- Request - Special Use Permit for used auto sales
- Location - 130 New Towne Square Drive
- Applicant / Owner - Feeras Khan
Khans Investments LLC
130 New Towne Square Drive
Toledo, OH 43612
- Architect - Walter J. Hales, AIA
Hales Architecture & Planning
3601 W. Alexis Road, Ste. 200
Toledo, OH 43623

The staff recommends that the Toledo City Plan Commission recommend approval of SUP24-00093, a Special Use Permit for used car dealership at 130 New Towne Square Drive, to the Toledo City Council, for the following three (3) reasons:

SPECIAL USE PERMIT
TOLEDO CITY PLAN COMMISSION
REF: SUP24-00093
DATE: November 7, 2024
TIME: 2:00 P.M.

SITE PLAN

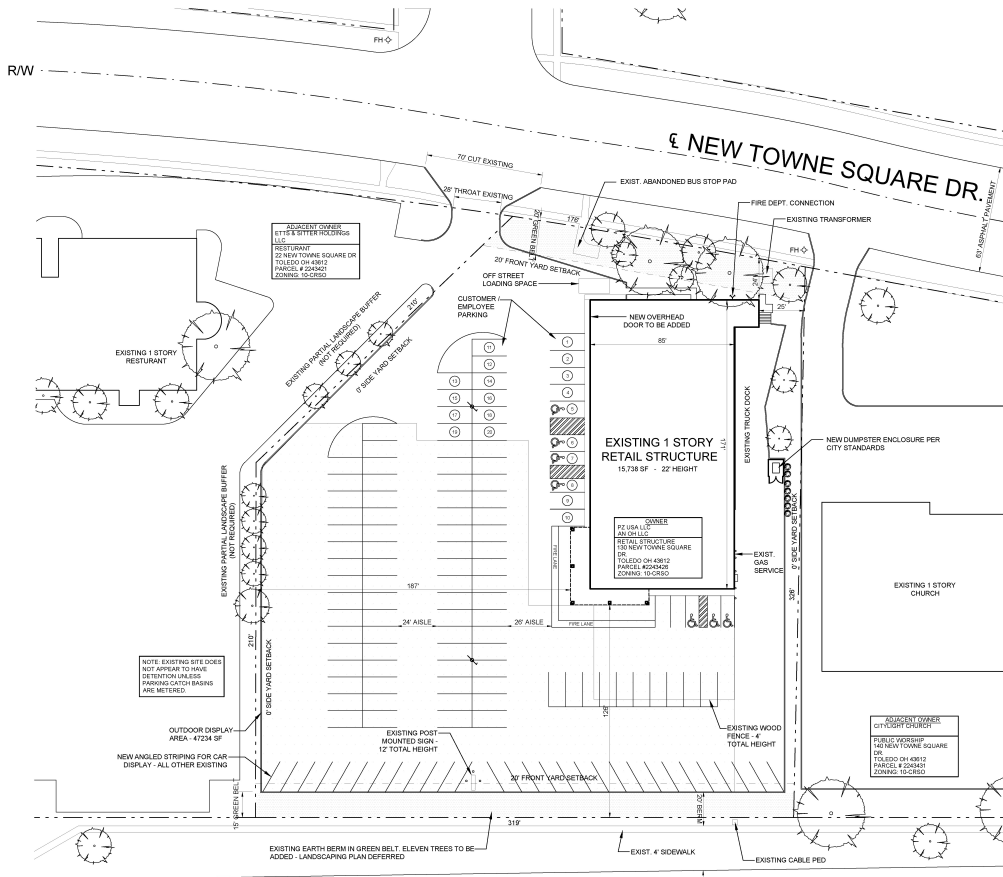
A four-foot (4') wood fence currently exists on the site south of the existing structure intersecting currently-delineated parking spaces. The site plan shows these spaces will be converted into outdoor display spaces. A revised site plan shall be submitted showing either the fence removed or the display spaces within the fence removed and listed as a condition of approval.

been shown; however, they are not clearly delineated from the outdoor display area spots. Per TMC§1104.0300, the required customer parking may not be used for used vehicle inventory. As a condition of approval, a revised site plan shall be submitted showing clear delineation between outdoor display area parking spots and customer/employee parking spots.

TMC§1107.1700 requires a portion of the total number of off-street parking spaces in each off-street parking area be specifically designated, located, and reserved for use by persons with physical disabilities. The submitted site plan shows four (4) of these accessible spaces for customer/employee parking and three (3) spaces within the outdoor display area. Since parking spaces within the outdoor display area are intended for the display of for-sale vehicles, not for customer/employee parking, there should be no need for accessible spaces within this area. A revised site plan shall be submitted showing no accessible parking spaces within the outdoor display area and listed as a condition of approval. With twenty (20) customer/employee parking spaces, one (1) van-accessible parking space is required per TMC§1107.1701. Should the number of proposed customer/employee parking spaces increase to twenty-six (26) or more based upon the previous delineation requirement, the number of required accessible parking spaces will also need to increase.

TMC§1107.1900 *Design Standards* applies to both customer/employee parking areas and outdoor display areas. Not all drive aisle and parking spot dimensions are shown; however, those that are shown reveal that the existing parking lot is not compliant with TMC§1107.1911 *Dimensions*. As a condition of approval, a revised site plan shall be submitted to both the Plan Director and the Division of Traffic Management showing all drive aisle and parking spot dimensions compliant with TMC§1107.1911.

24. Used vehicle inventory shall only be displayed, parked or located within the outdoor display area defined on the site plan.
25. The existing four foot (4') wooden fence between the structure and Alexis Road shall either be removed or have all parking/display spaces removed from within its enclosure. **This shall be depicted on a revised site plan submitted to the Plan Director.**

26. Off-street parking spaces for customers/employees shall be clearly delineated from spots within the outdoor display area. **Not acceptable as depicted. A revised site plan shall be submitted to the Plan Director depicting a clear delineation between outdoor display area parking spots and customer/employee parking spots.**

29. Accessible spaces may not be included within the outdoor display area. **Not acceptable as depicted. A revised site plan shall be submitted to the Plan Director depicting no accessible parking spaces within the outdoor display area.**

31. All drive aisle and parking spot dimensions shall be shown to be compliant with TMC§1107.1900 *Design Standards*. **Not acceptable as depicted. A revised site plan shall be submitted to the Plan Director and Division of Traffic Management showing compliance with all design standards.**

LANDSCAPE PLAN

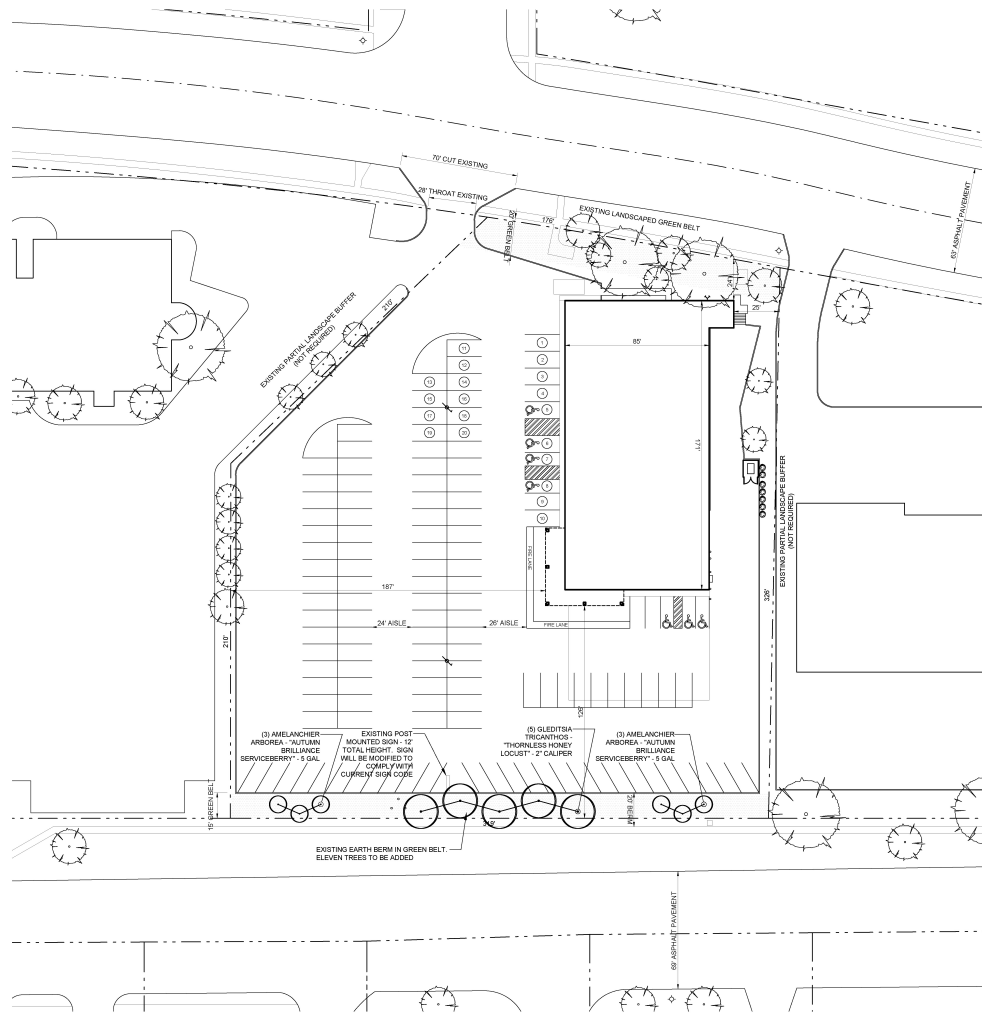
approved by the Plan Director. An acceptable earth berm exists along Alexis Road; however, no such berm exists along New Towne Square Drive. A revised landscape plan shall be submitted depicting a solid evergreen hedge within the frontage greenbelt along New Towne Square Road in front of the parking lot and listed as a condition of approval.

Perimeter parking lot landscaping is also required along the eastern property line. There are two (2) existing trees between the parking lot and the property line. No other trees are proposed or shown on the submitted landscaping plan; however, eleven (11) trees are required on this area. While the existing trees may be credited as multiple trees, staff does not anticipate this requirement will be met. As a condition of approval, a revised landscaping plan must be submitted depicting additional trees to meet the eleven (11) trees required. In order to count for tree credits, existing trees must have their species and caliper verified and depicted on a revised landscaping plan.

Perimeter parking lot landscaping must also contain continuous shrubs with a minimum height of eighteen inches (18") when installed so as to achieve full screening at maturity. The submitted landscaping plan shows screening shrubs only along a small portion of the eastern property line. A revised landscaping plan must be submitted showing continuous shrub plantings along both the eastern and western property lines. If the applicant cannot receive permission to plant continuous shrubs within the existing landscape strip on the adjacent property to the west, the landscaping area may need to be expanded onto the subject property.

- b. A fifteen-foot (15') buffer of landscaped frontage greenbelt is required along New Towne Square Drive. At least one tree must be provided for every 30 feet of lot frontage. The frontage greenbelt shall also include a solid evergreen hedge to screen parking in the front of the property and prevent headlights from being seen from the right-of-way. **Not acceptable as depicted. A revised landscaping plan shall be submitted to the Plan Director depicting a solid evergreen hedge within the frontage greenbelt along New Towne Square Road where the parking lot is visible.**

- c. Perimeter parking lot landscaping is required along the western property line. A minimum of one (1) canopy tree must be provided for each thirty linear feet (30'). **Not acceptable as depicted. Fourteen (14) trees required. Existing trees on the abutting property may be credited for multiple trees per TMC§1108.0407. In order to count for tree credits, trees must have their species and caliper verified and depicted on a revised landscaping plan.**

- d. Perimeter parking lot landscaping is required along the eastern property line. A minimum of one (1) canopy tree must be provided for each thirty linear feet (30'). **Not acceptable as depicted. Eleven (11) trees are required. Existing trees on the abutting property may be credited for multiple trees per TMC§1108.0407. In order to count for tree credits, trees must have their species and caliper verified and depicted on a revised landscaping plan.**

- e. Perimeter parking lot landscaping along the eastern and western property lines must contain continuous shrub plantings with a minimum height of eighteen inches (18") when installed so as to achieve full screening at maturity. **A revised landscaping plan shall be submitted to the Plan Director depicting continuous shrub plantings along both the eastern and western property lines. Western property line shrub plantings may be depicted on the adjacent property if permission is given by the adjacent property owner.**
